DRAWINGS

REMARKS

Annotated
 Marked-Up Drawing

FIG.-3

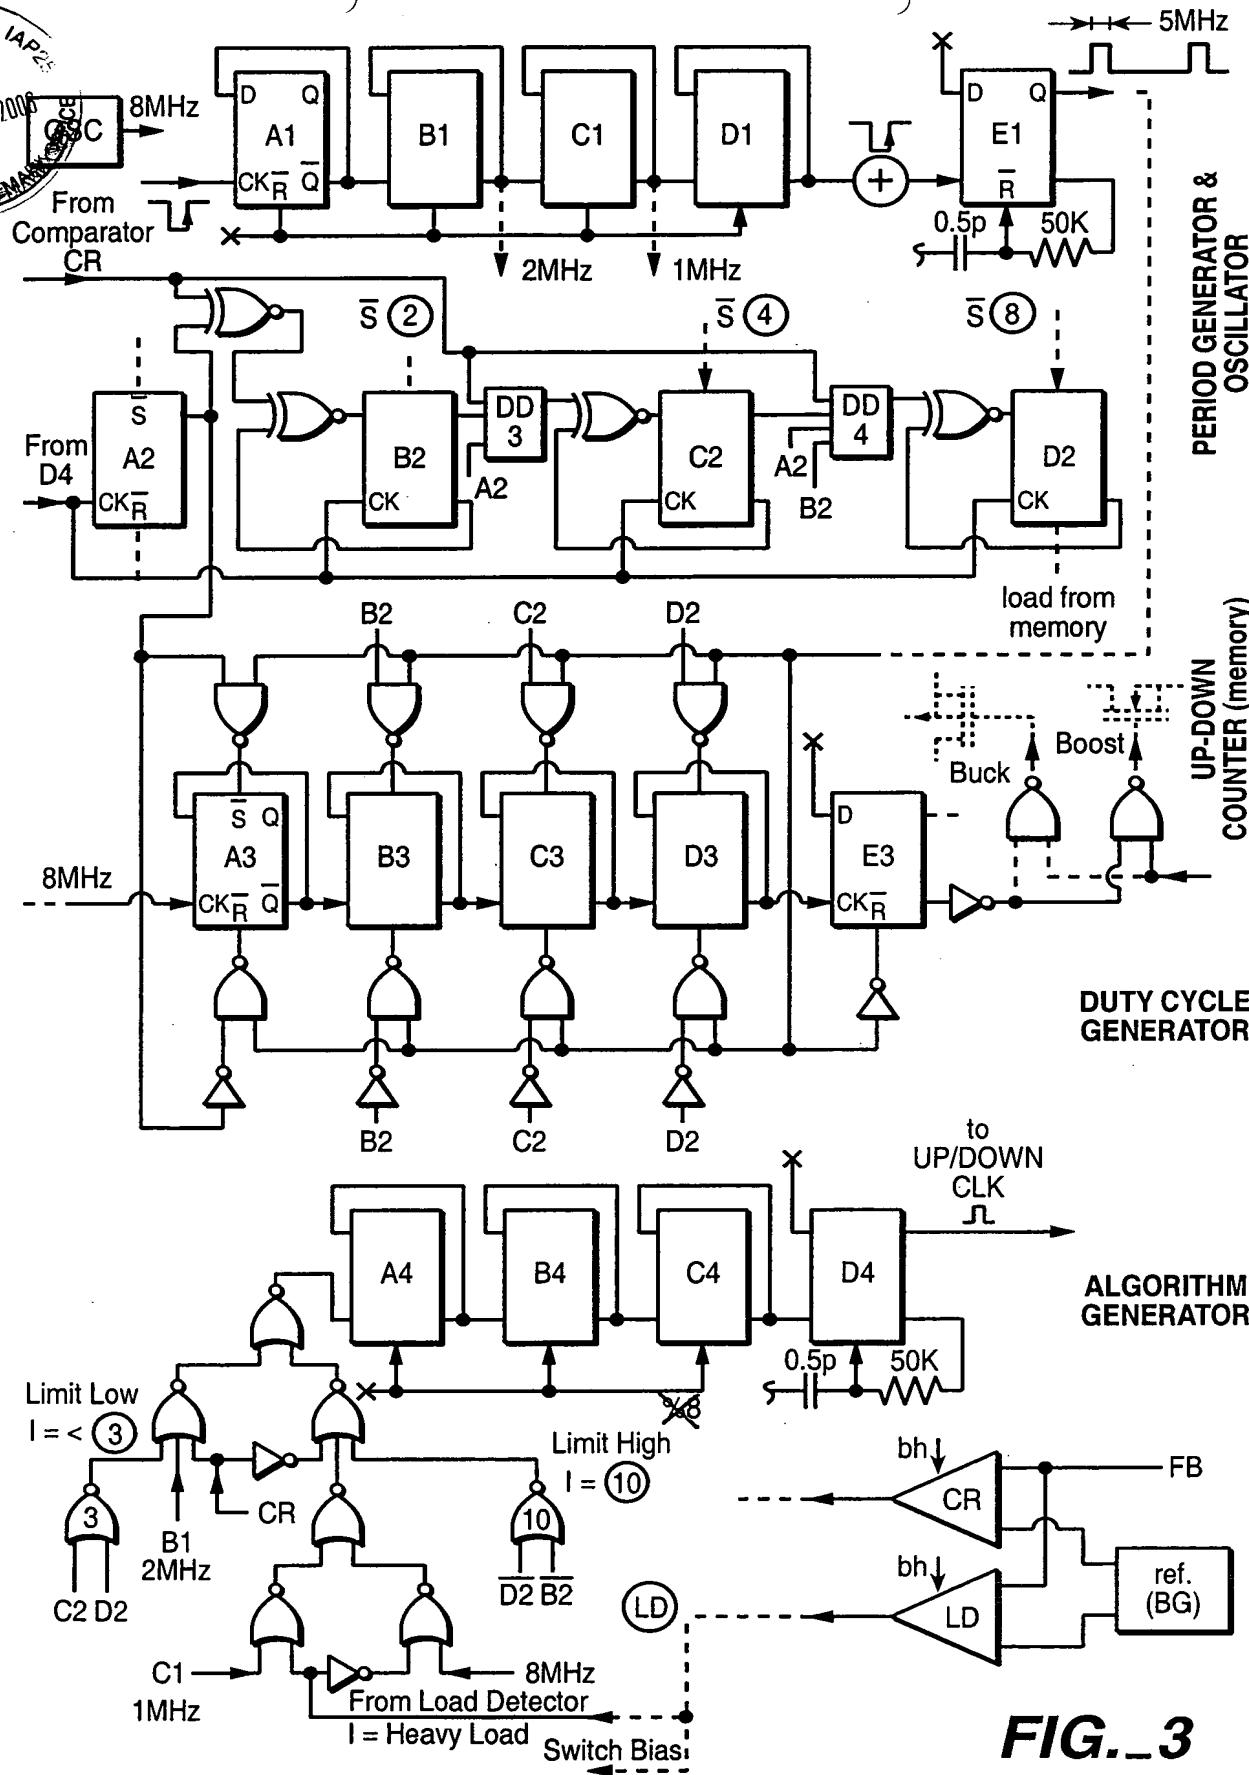
The Examiner objected to the drawings. According to the Examiner, “[I]t is unclear in Fig. 1A – Fig. 1D whether voltage feedback or the rate of change of voltage with respect to time is feedback. In Fig. 3 ‘bh’ and ‘%8’ are not defined. Furthermore, signals A2, B2, C2 and D2 are not properly defined.”

Amend FIG. 3 of the Application as shown in the attached marked-up drawing. A replacement sheet for the amended drawing is also attached.

Applicants have amended FIG. 3 to remove the “%8” from the drawing. The remainder of the signals—bh, A2, B2, C2, and D2—would be understood to one of skill in the art in the context of FIG. 3. Thus, the objection to FIG. 3 should be withdrawn.
